# Value Engineering Study

**Kentucky  
Transportation Cabinet**

**I-65 & KY 222 Interchange**

**Hardin County**

Alternative No.: IO-5

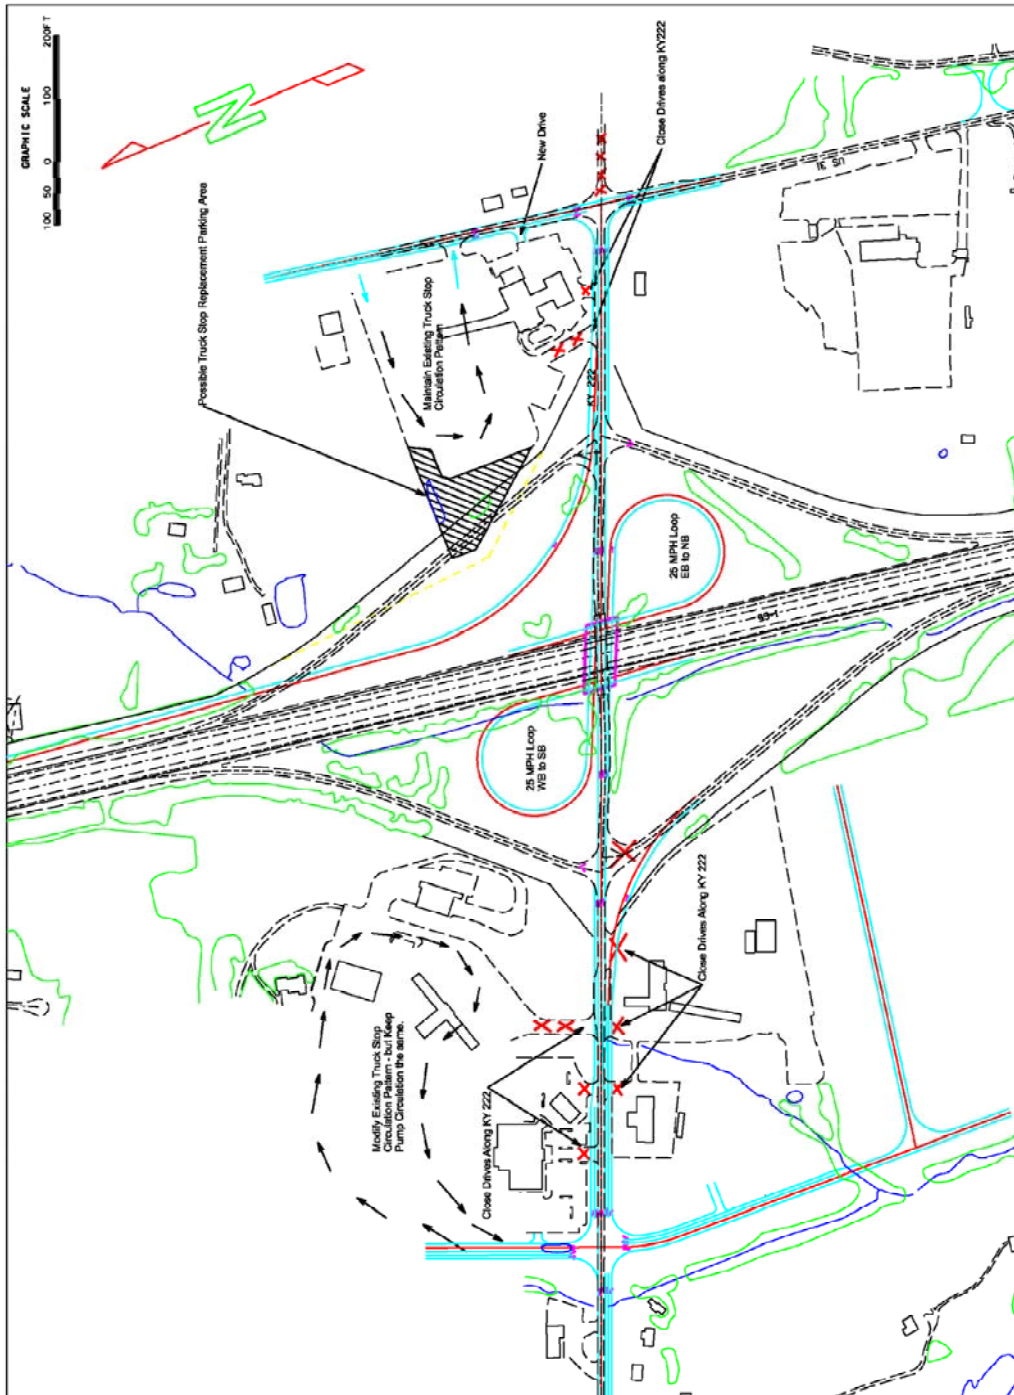
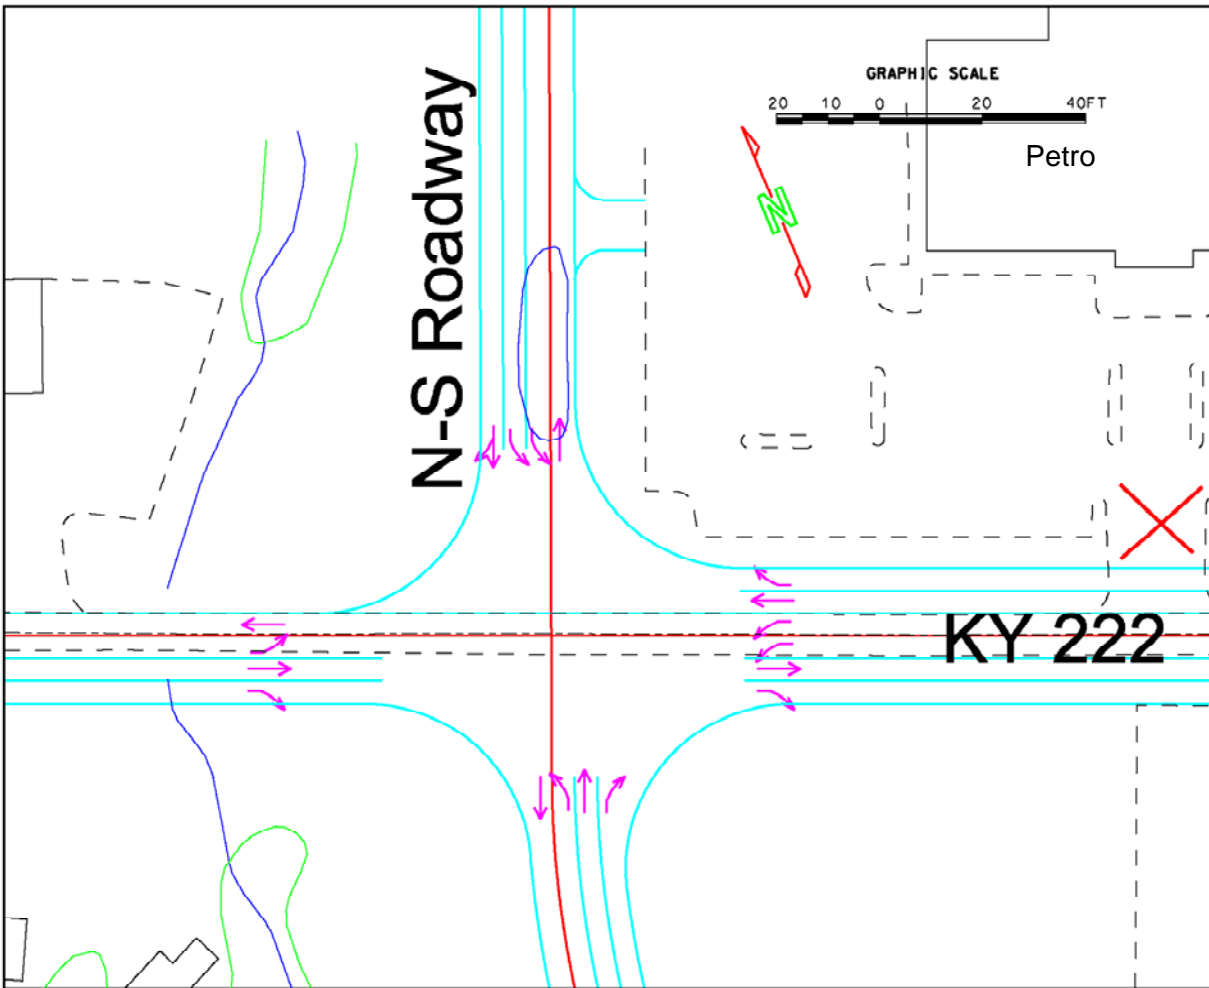
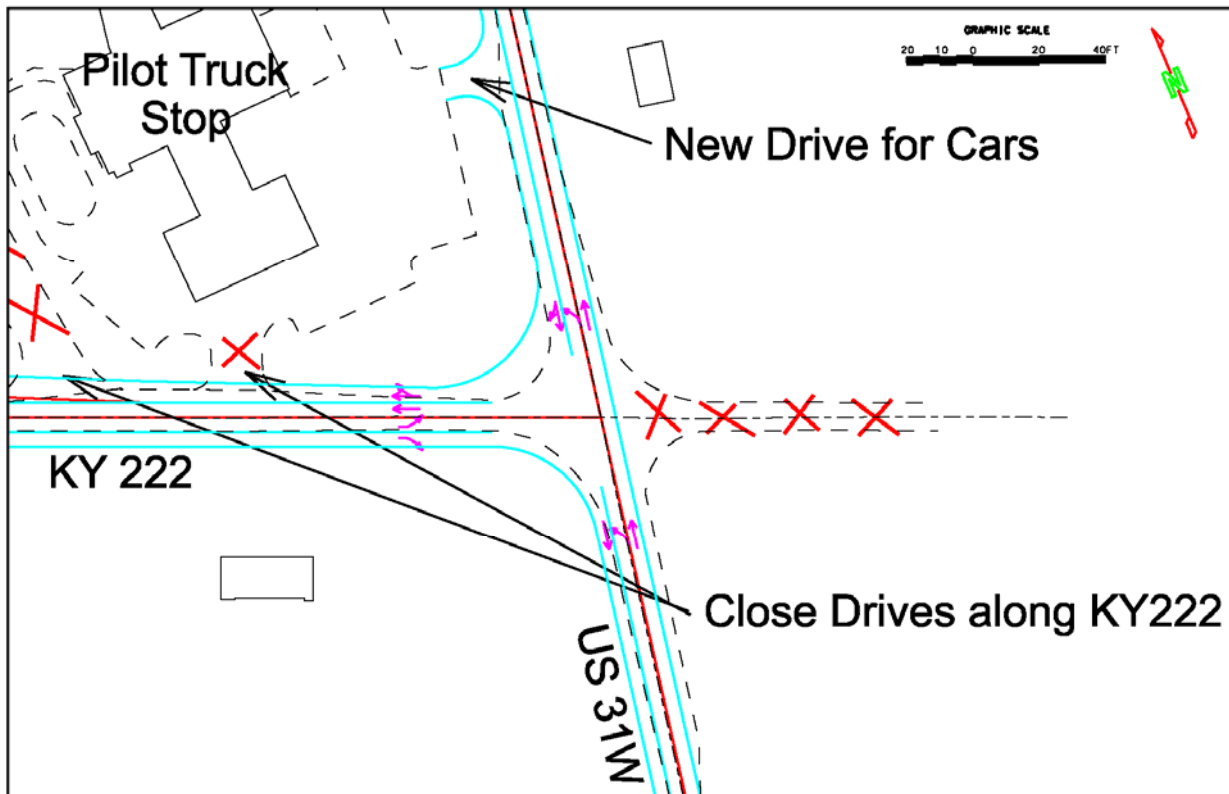
A new intersection on KY 222 would be created just west of the Petro truck stop by constructing a new north-south (NS) roadway. The driveways for the Petro (both truck and car entrances) as well as the driveways to Glendale Economy Inn and Country Style Plaza would be relocated to this new NS roadway. The new NS roadway would provide access to the potential future industrial development site. The existing commercial driveways along KY 222 would be closed to provide approximately 1,200 feet between the ramp intersection and the NS roadway.

The Petro parking lot would likely need to be re-stripped to change the circulation for trucks traveling to the gas pumps.

Land vacated by the westbound to northbound entrance ramp could be considered to use as an expansion of the Pilot Travel Center parking lot. These could be used to replace parking spaces and the oil change facility which may be lost due to the proposed change in circulation pattern.

Construction sequencing of this concept would require partial width construction of most features of this project. The bridge, ramps, KY 222, and US 31W would need to be constructed half at a time to maintain traffic.

Traffic operations in the design year 2030, assuming the development site is operating, the ramp intersections in the AM peak hour will operate at a LOS A/B and in the PM peak hour will operate at a LOS C/B.

Alternative No.: IO-11

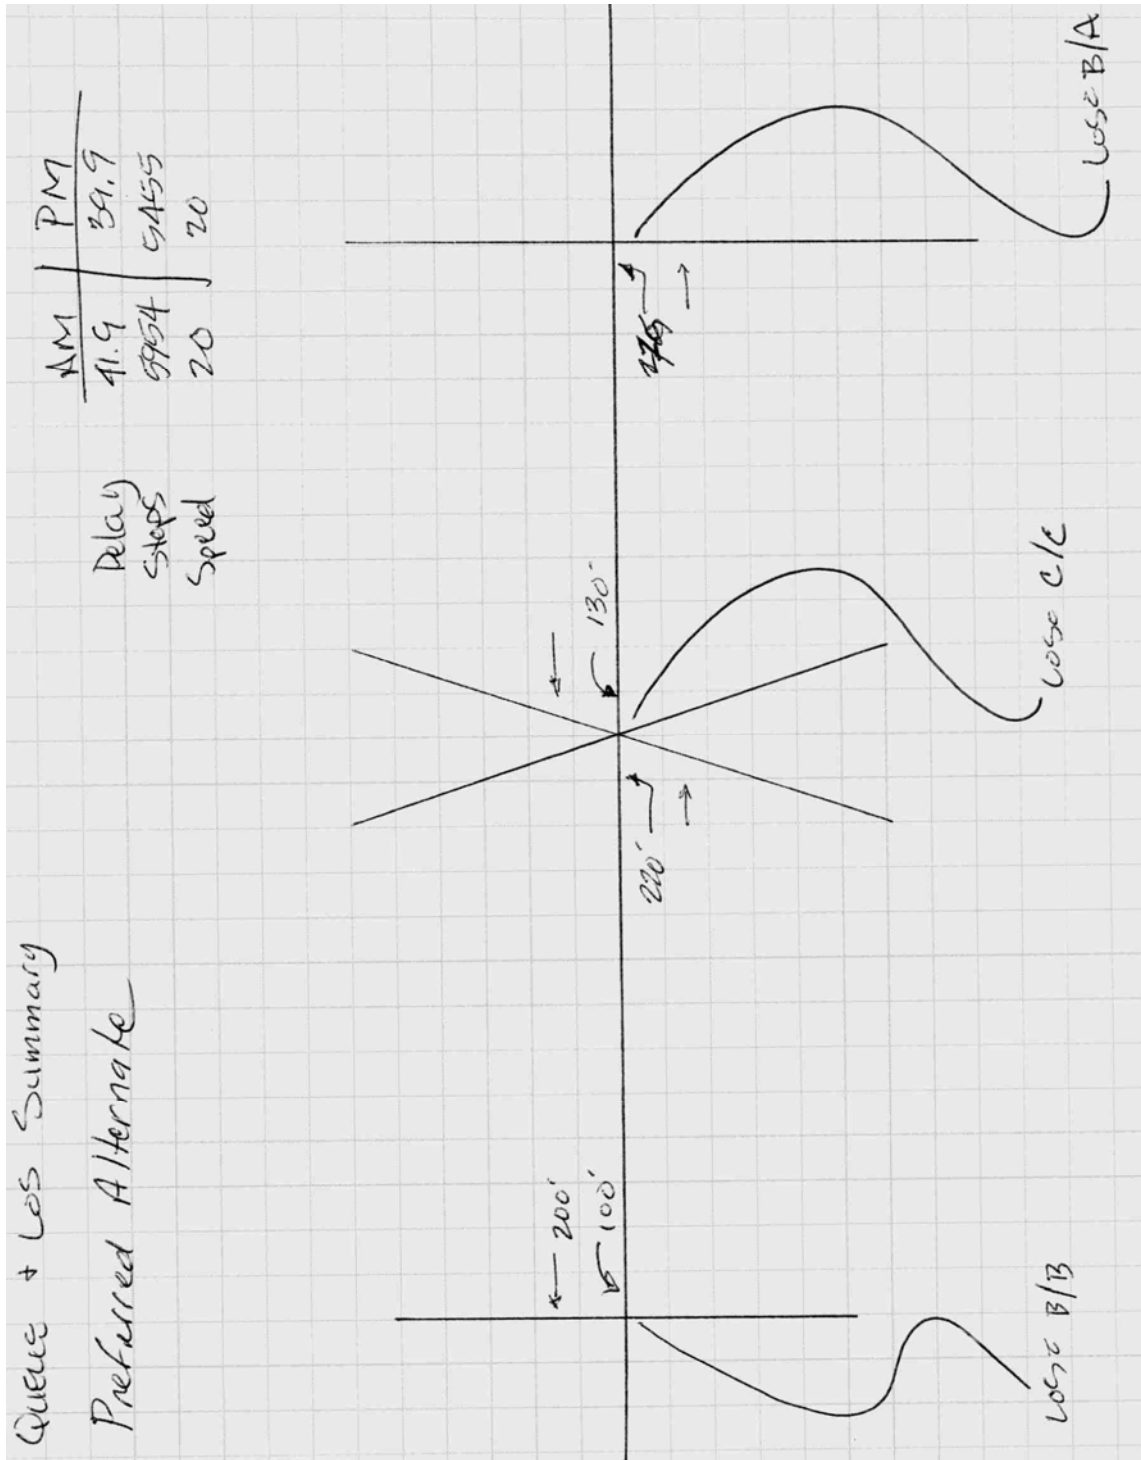
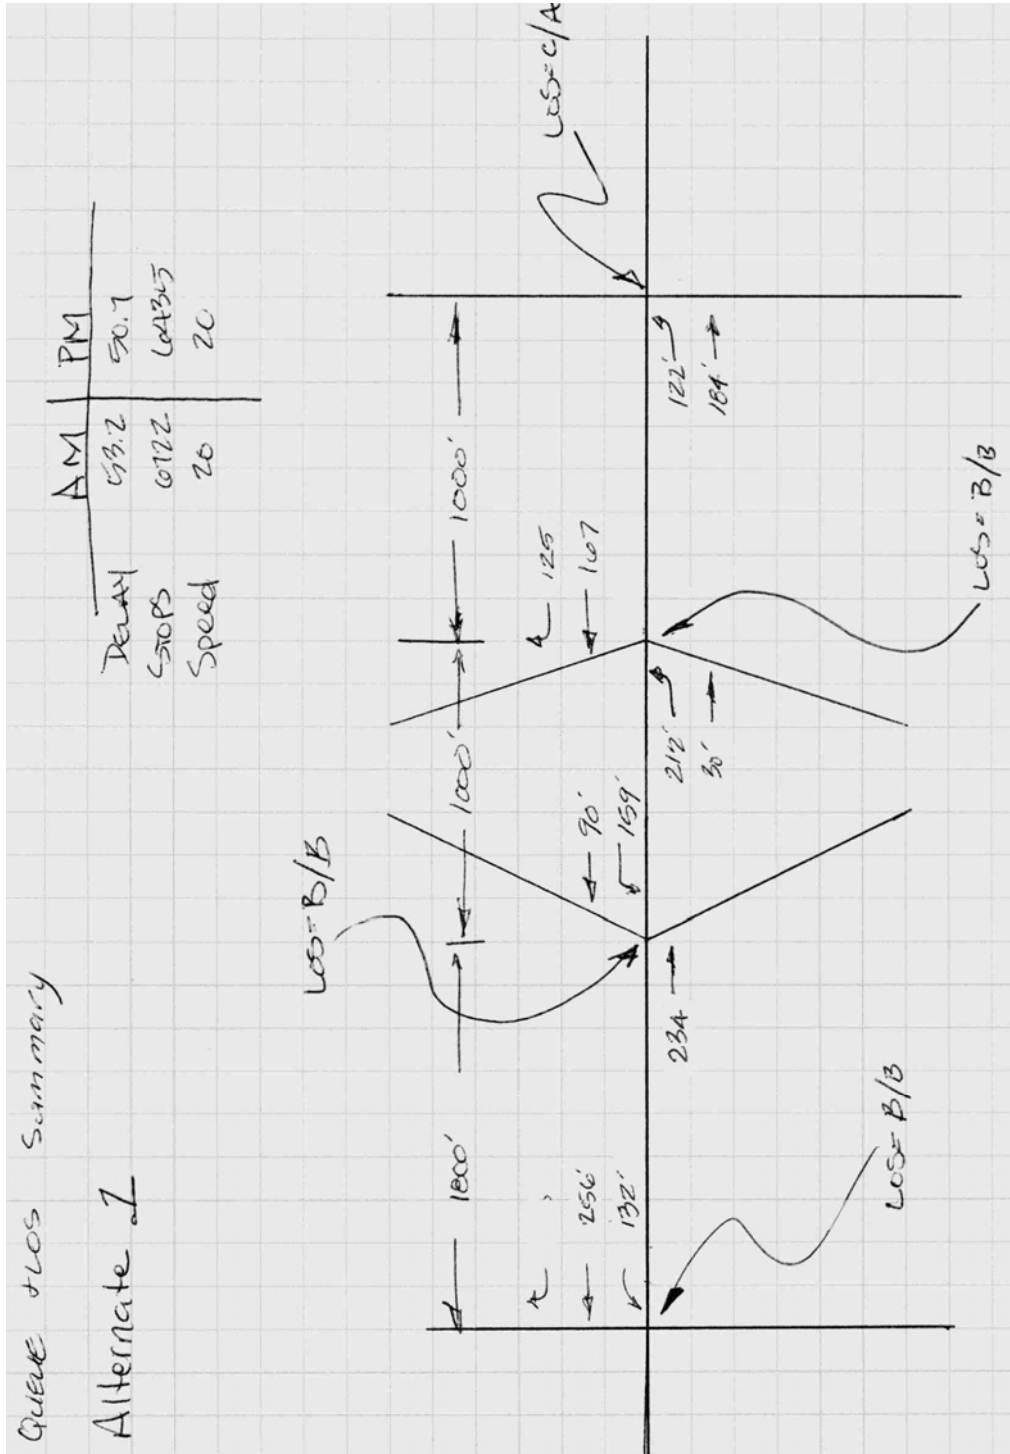
MOE	System Performance Alternative 1: Diamond Interchange		System Performance Preferred Alternate	
	AM Peak	PM Peak	AM Peak	PM Peak
Delay (sec/veh)	53.2	50.7	41.9	39.9
Stops	6722	6435	5954	5455
Average Speed (mph)	20	20	20	20

Evaluation of the operational analysis indicates that there will not be any operational deficiencies either as a result of delay and/or queuing. System performance for the diamond interchange shows an average of 10 seconds per vehicle higher than the proposed alternative and approximately a 17 percent increase in stops. These increases are attributable to the additional signal required by the diamond interchange. However, the average estimated speed through the corridor is the same for both alternatives. Overall the diamond provides an adequate level of service for the new alignment of KY 222.
